**REGULAR MEETING  
CONSERVATION COMMISSION  
1 JUNKINS AVENUE  
PORTSMOUTH, NEW HAMPSHIRE  
SCHOOL DEPARTMENT CONFERENCE ROOM**

**September 11, 2024**

TO: Conservation Commission Members  
FROM: Kate Homet, Associate Environmental Planner; Peter Britz,  
Director of Planning and Sustainability  
DATE: September 6, 2024  
SUBJ: September 11, 2024 Conservation Commission Meeting

**Response to Conservation Commission Comments**

**1** Deciduous Tree Planting  
1":1'-0" 9.1

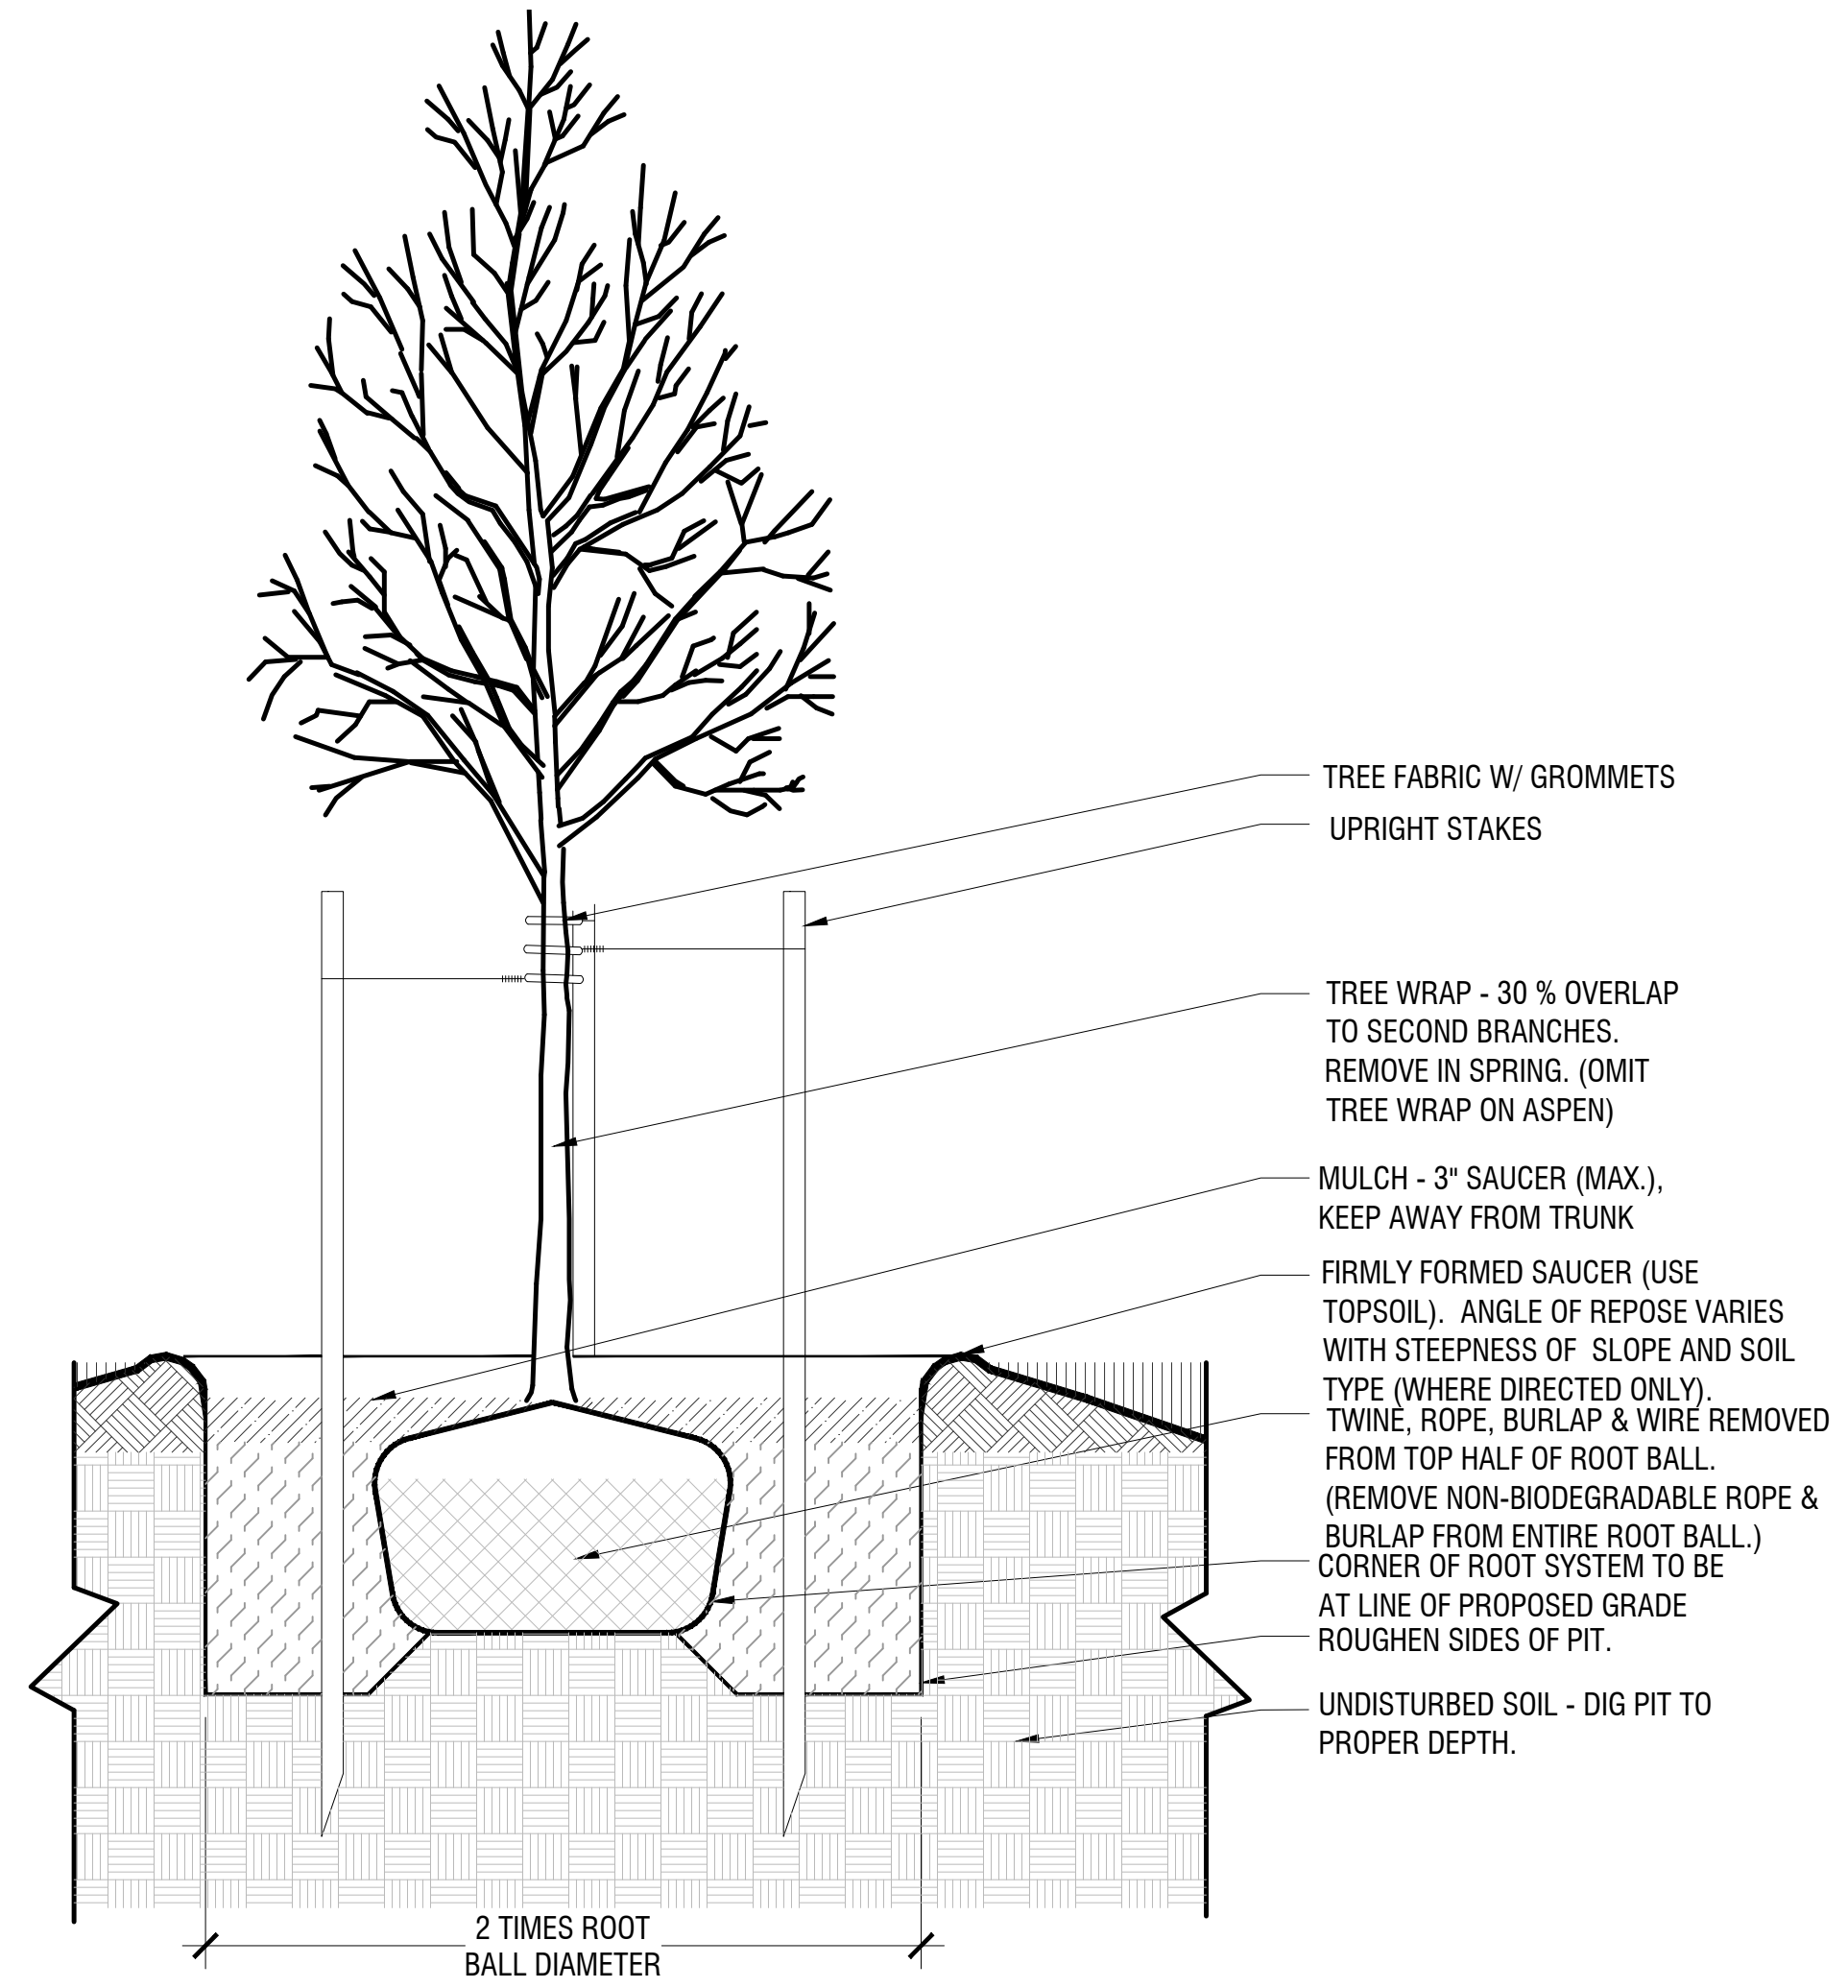
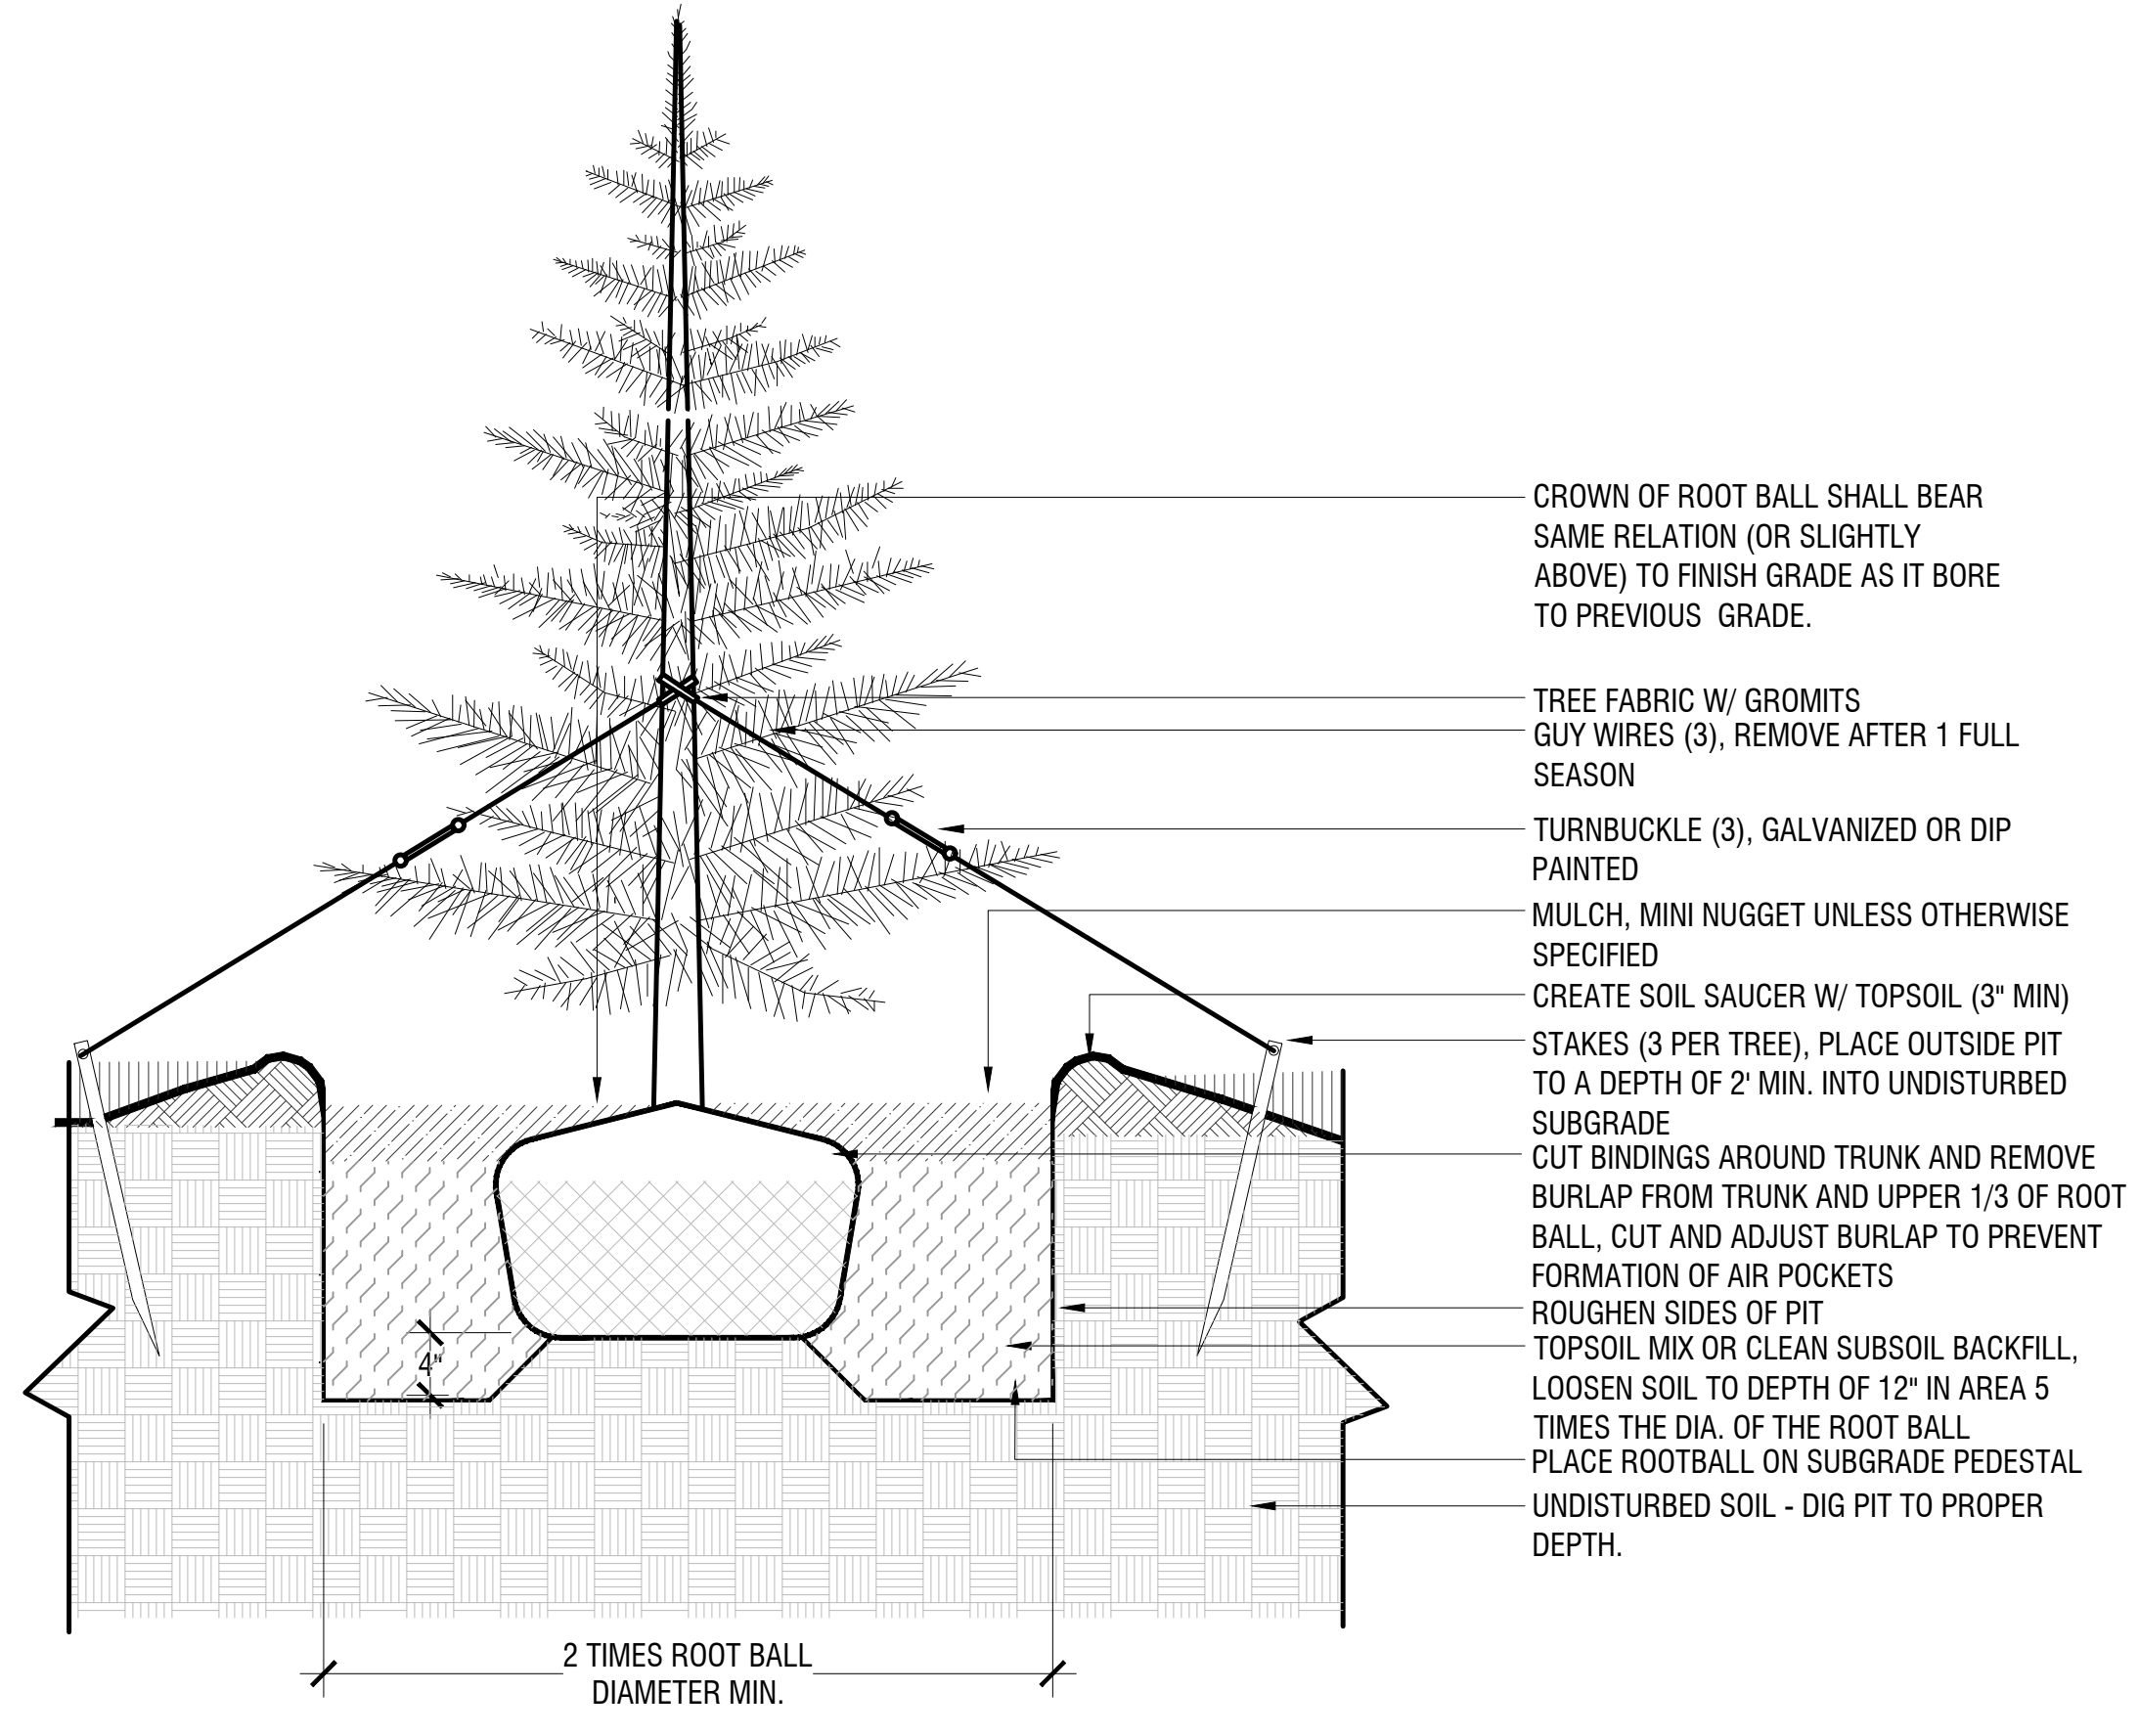
2. *Specify planting and tree sizes, types and locations.*

**Response:** Refer to Sheet L3-00 for full planting schedule and plan.
